***Limited-Sight* Site Walk 2020** **+ Accepting “Fantasy Images” vs. “Illustrations”**

Submitted to the Durham Planning Board, February 3, 2022

Adapted from Public Comment, Planning Board, Jan 12, 2022, 8:11:24 pm ([video](#))

Joshua Meyrowitz, 7 Chesley Dr, Durham, NH Prof.Joshua.Meyrowitz@gmail.com {s}

Chesley Drive Realities vs. Fantasies

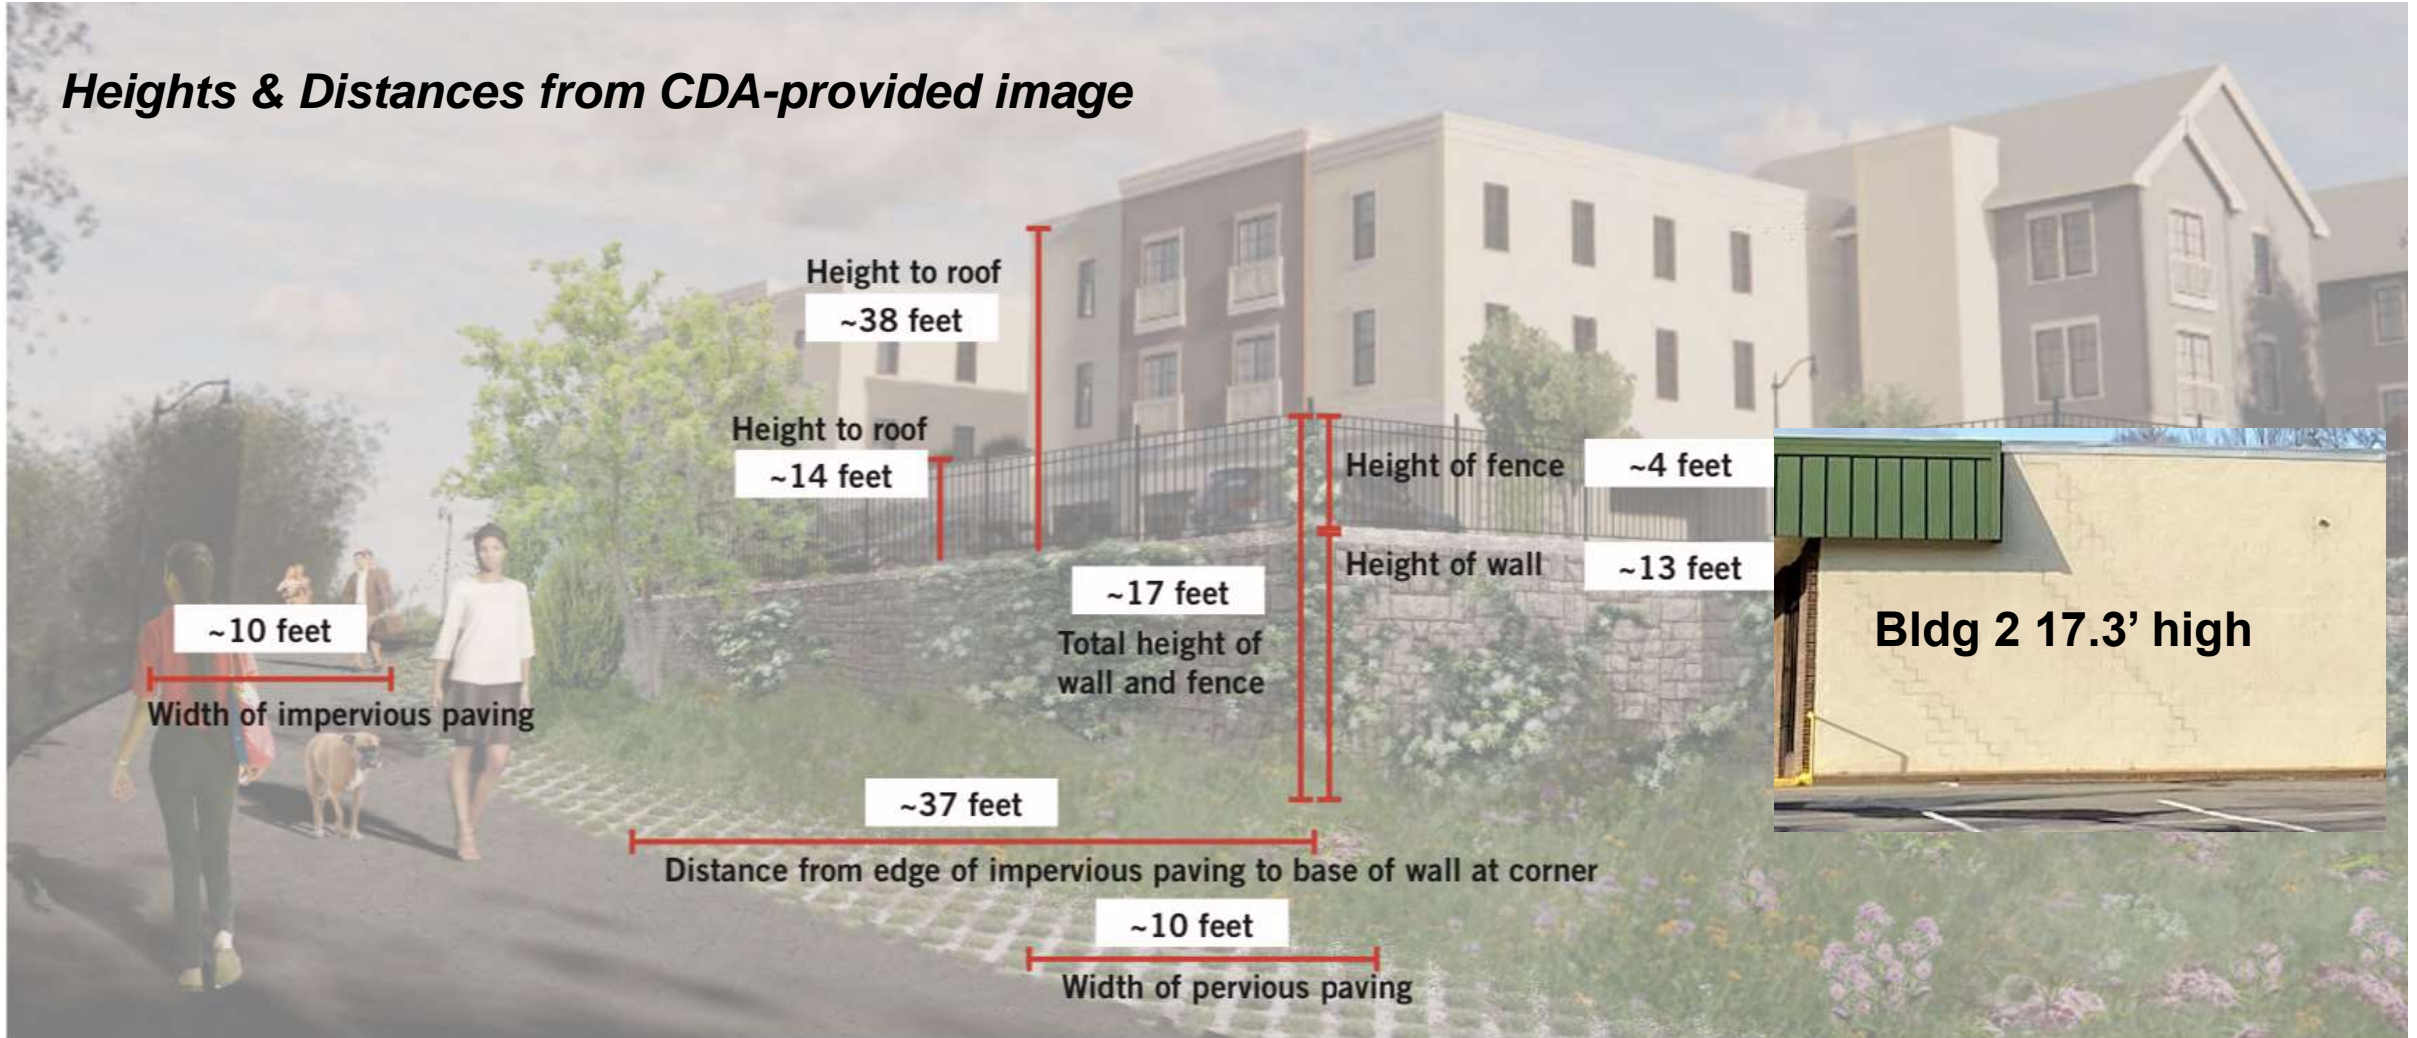
CDA “erases” massive proposed 51 ft tall structure into Disneyfied “magic forest” post-construction fantasy image.

**Why hasn't the
Planning Board
demanded accurate
info & *illustrations*
from CDA?**

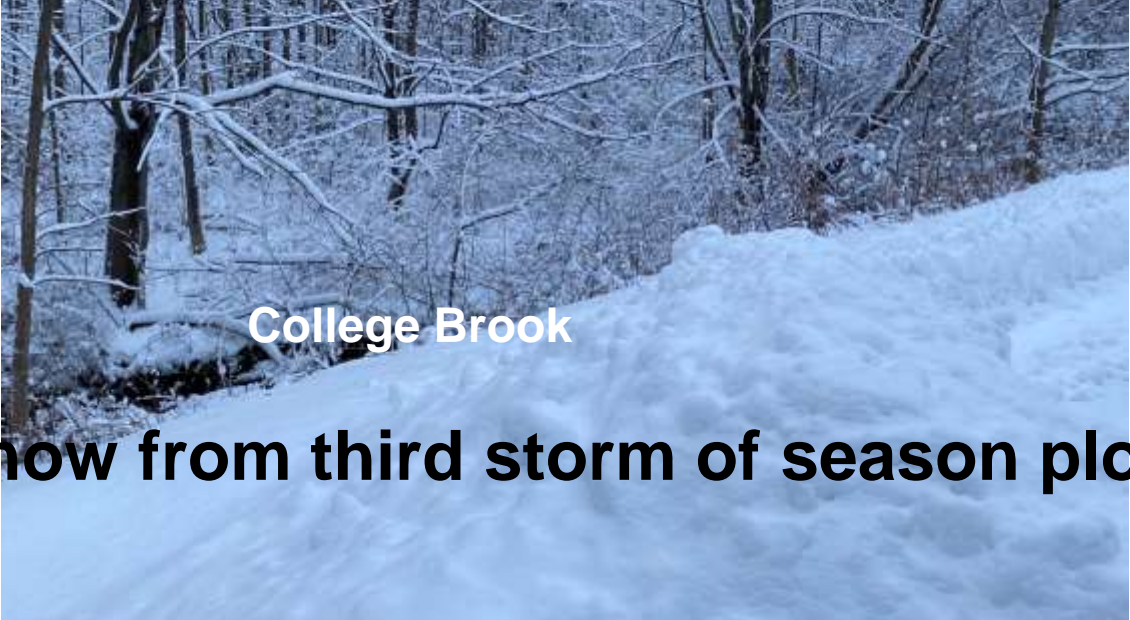
Dec 19, 2021 Storm Plowing [VIDEO](#) (00:21)
Town staff forwarded to NHDES.

Dec 26, 2021 Storm Plowing [VIDEO](#) (00:19)
Prior mounds pushed further into bank

Plowing snow directly into College Brook bank, during first two small snowstorms of season

*Per Colonial Durham's
"Tree Plantings" diagram, an
"Existing Tree to Remain"*

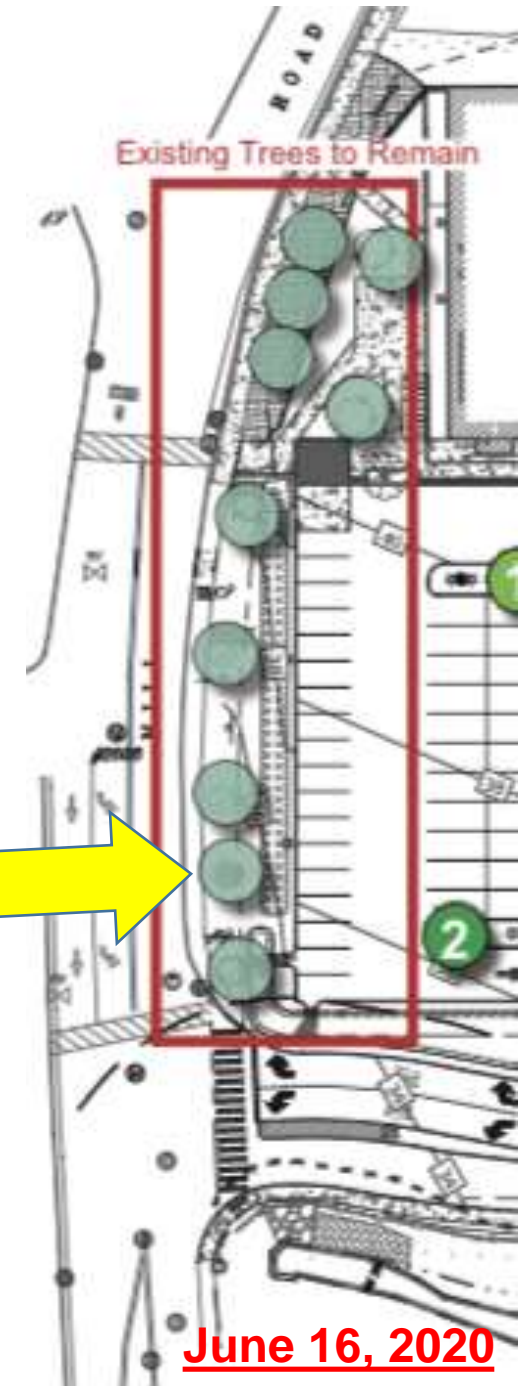
A full site walk would compare plans to what's on the ground.

**Why wasn't the laughter after this was shown followed
by a PB demand for CDA to address the issue?**

2021 Site Plans, p. 7

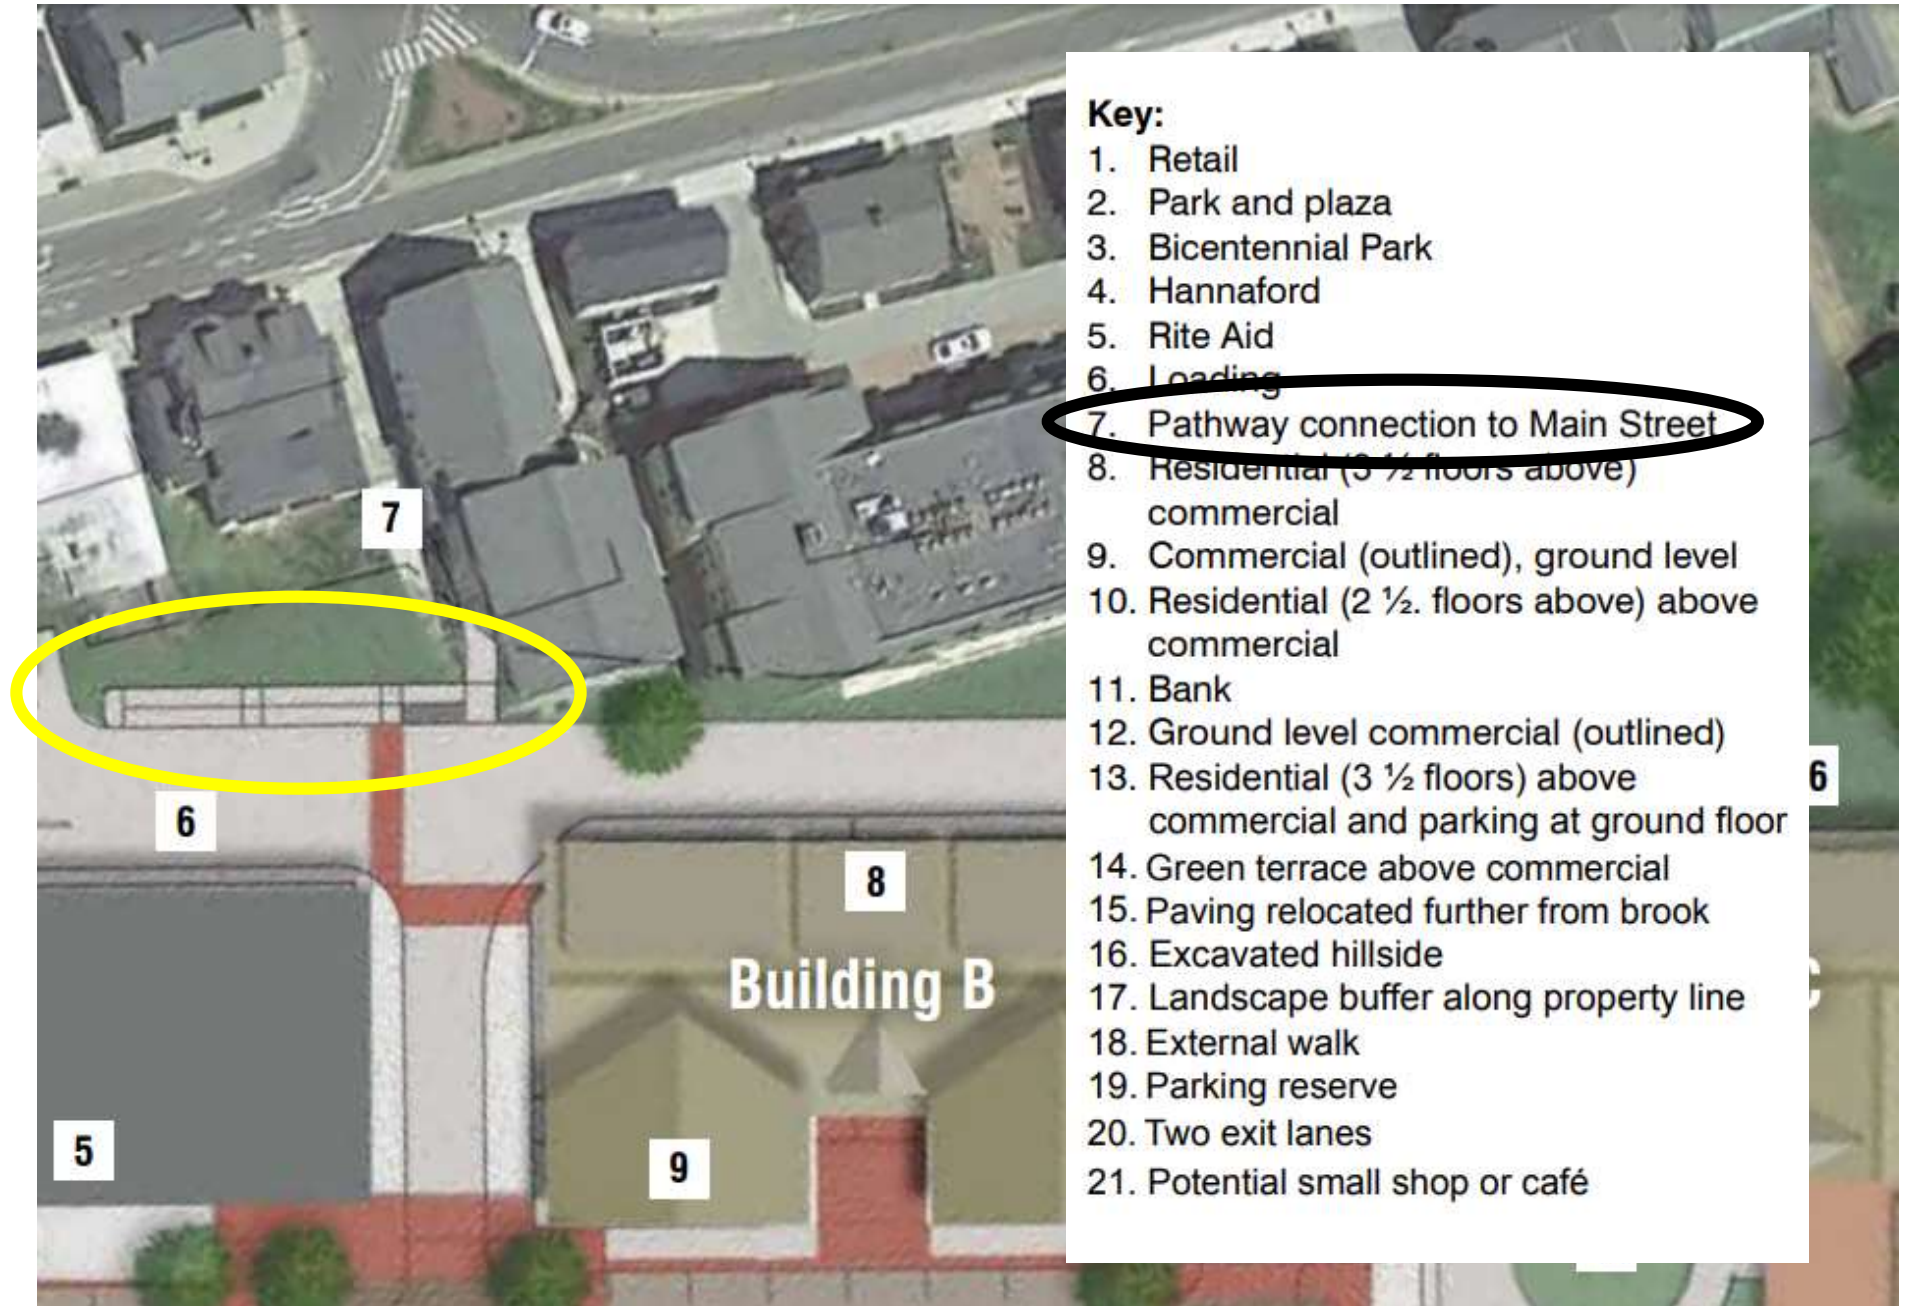
Very popular footpath from Plaza to Main St & Post Office to be taken out, replaced with switchback staircase.

Aug 25, 2021: Planning Board Chair scoffed at idea that ADA-compliant ramp was possible in this location & argued in favor of CDA's plan to put in a switchback staircase (9:45p)

Then a local architect who worked on the 2008 Mill Plaza Study Committee submitted ADA design: Isaak Design—ADA Compliant Pathway 10-21-21. But, on **Oct 27, 2021**, the PB Chair did not challenge CDA's refusal to consider it.

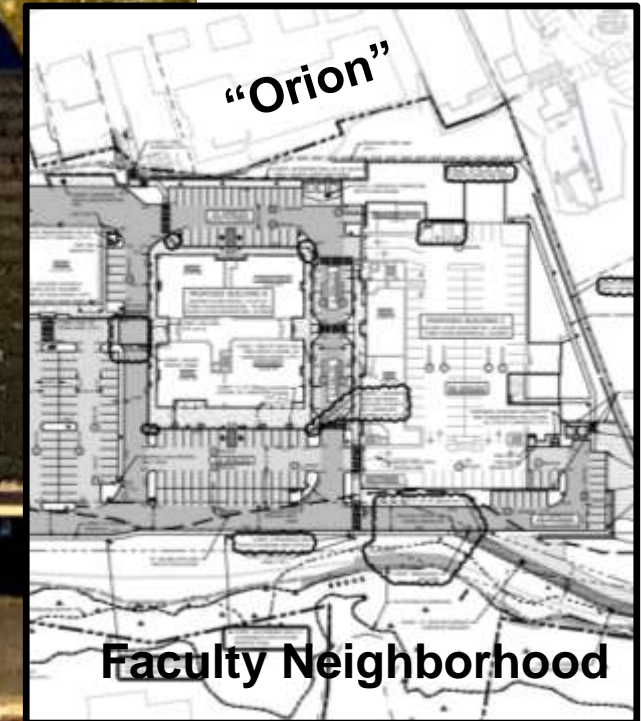
In 2021 plans, Bldg C is much *closer* to Faculty Rd than it was in 2016 plan!
